Item 6
At Central Sydney Planning Committee
22 October 2026

Relevant Information for Central Sydney Planning Committee

FILE:	**X104453**	**DATE:**	22 October 2026
TO:	Central Sydney Planning Committee		
FROM:	Graham Jahn AM, Chief Planner / Executive Director City Planning, Development & Transport		
SUBJECT:	Information Relevant To Item 6 – Public Exhibition - Planning Proposal - 84-86 and 88-94 Parramatta Road, Camperdown - Sydney Local Environmental Plan 2012 and Sydney Development Control Plan 2012 Amendment

Planning Proposal – 84-86 and 88-94 Parramatta Road, Camperdown

Figure 27. Building envelope - plan

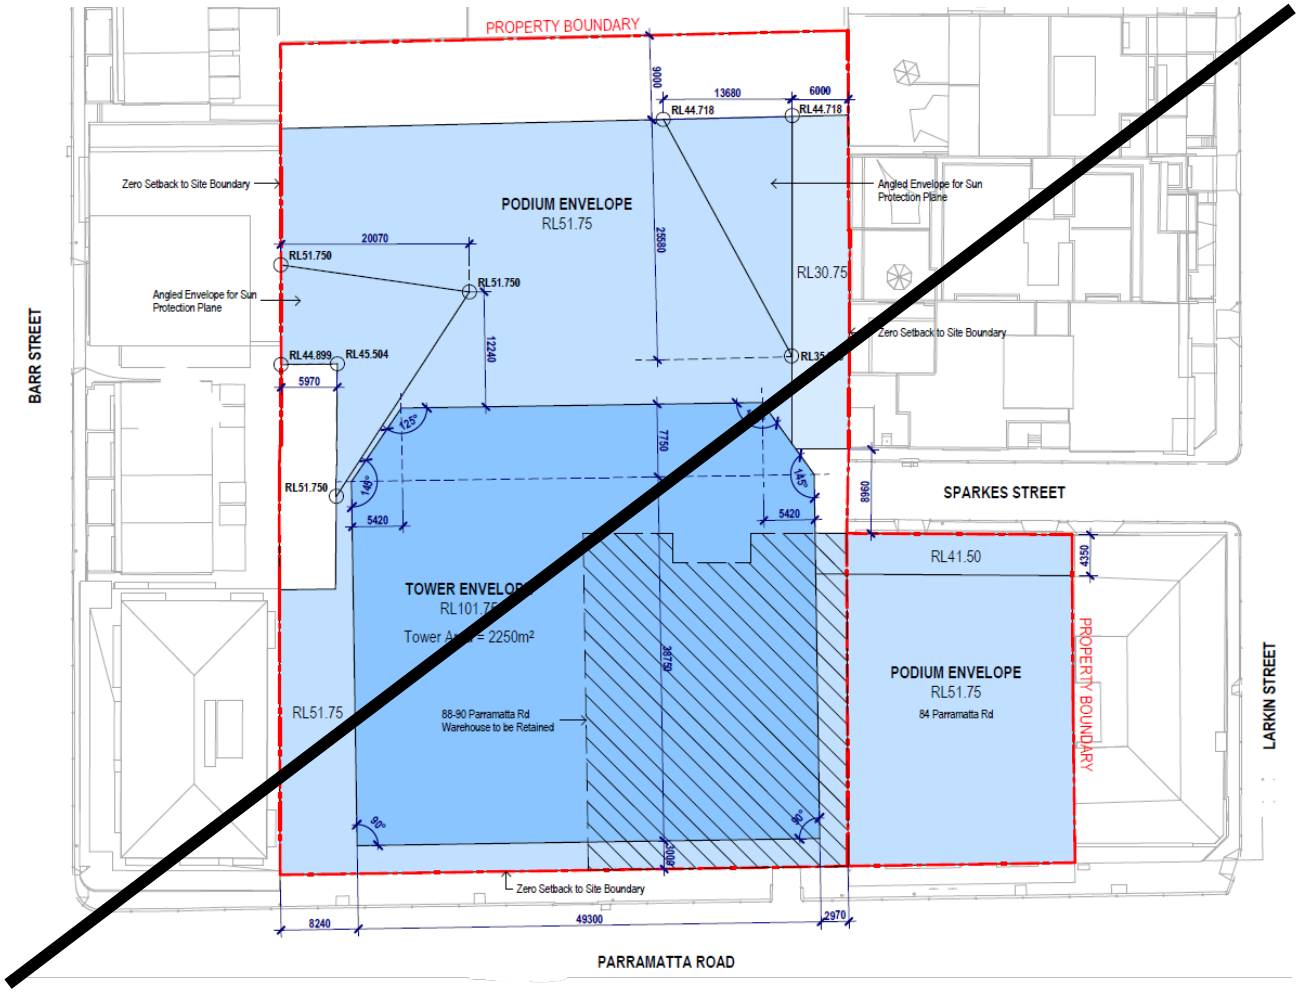
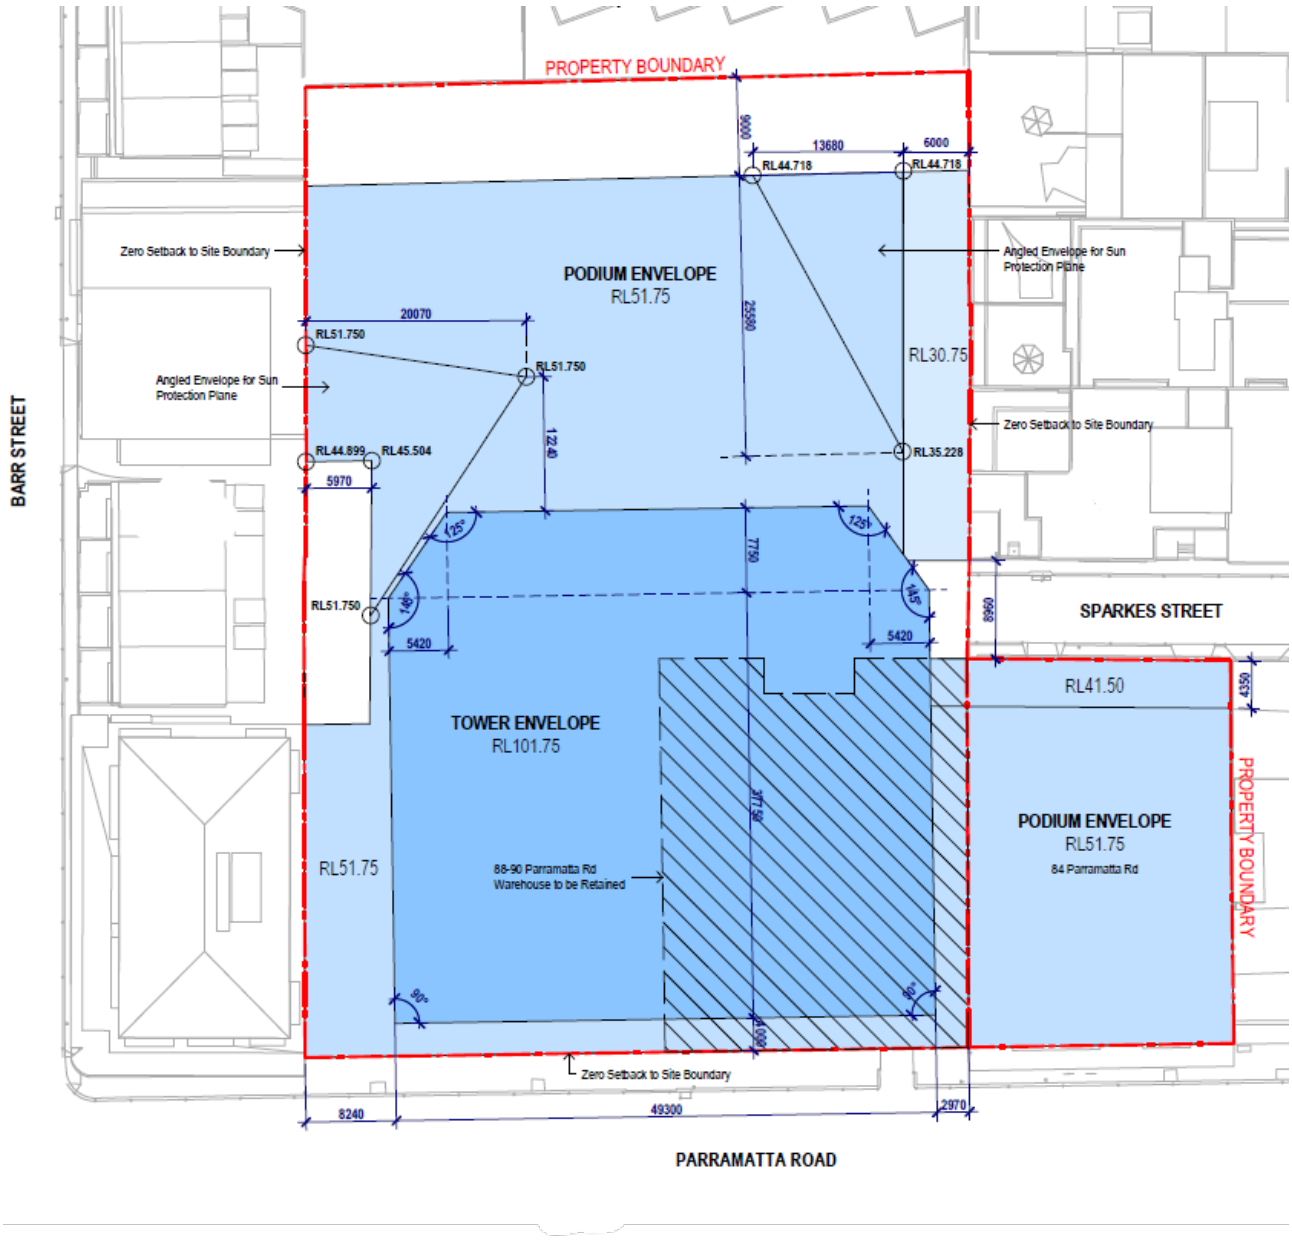
The building envelope, as defined in 'Figure 6.X - Building envelope - plan' in draft Sydney Development Control Plan 2012 - 84-86 and 88-94 Parramatta Road, Camperdown, had previously required a minimum 3 metre setback for the tower envelope from the southern property boundary along the Parramatta Road frontage.

To increase the visual separation of tower and podium, and improve amenity outcomes along Parramatta Road, the minimum setback has been increased from 3 metres to 4 metres. The draft DCP, at Attachment B, has amended the relevant figure and Figure 27 of the planning proposal at Attachment A has also been updated.
